Subject: 10CFR21 Reporting of Defects and Non-Compliance -
Engine Systems, Inc. Report No. 10CFR21-0089, Rev. 0

Woodward Governor "Compensating" EG Series Actuators

Report No. 10CFR21-0089
Rev. 0: 04/12/05

10CFR21 REPORTING OF DEFECTS AND NON-COMPLIANCE

FIGURE 1: TYPICAL EGB-C "COMPENSATING" GOVERNOR

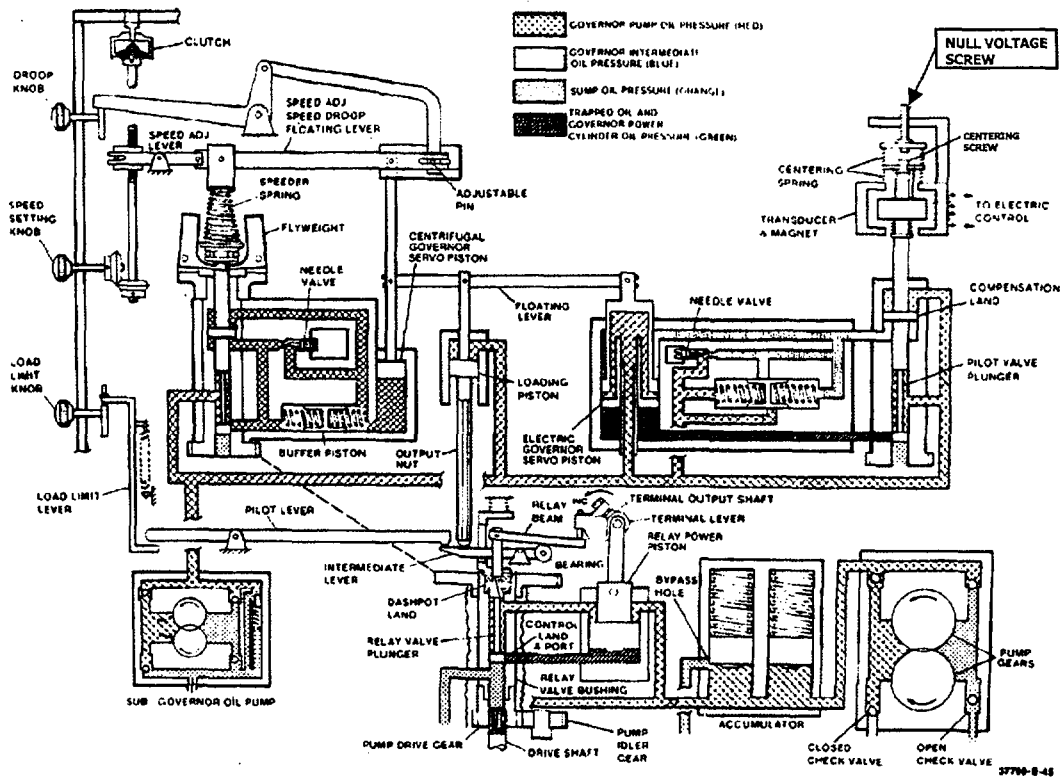
Proportional actuators (EGB-13P, 35P, etc.) have an internal feedback (a mechanical link) between the electrical power piston and electrical section pilot valve. This feedback, which is not provided on the compensating actuators, eliminates the concern of drift because any deviations within the centering restoring spring, pilot valve, etc. are overcome as the power piston and pilot valve come to equilibrium. Reference Figures 1 and 2.

The null voltage shift that occurred at Perry changed the actuator from "fail to maximum fuel" to "fail to minimum fuel" and thus resulted in a start failure. Users with compensating governor systems need to be aware that this characteristic, if significant enough, could affect operability of their safety related system.

Users with compensating governor systems should consider upgrading to a proportional governor system. For EGB-C systems with EGA or EGM controls, the EGB-P and 2301A load sharing and speed control is the recommended replacement. For EG-R systems with EGM controls, the PGPL actuator with a PGPL driver and 505 controller is the recommended replacement.
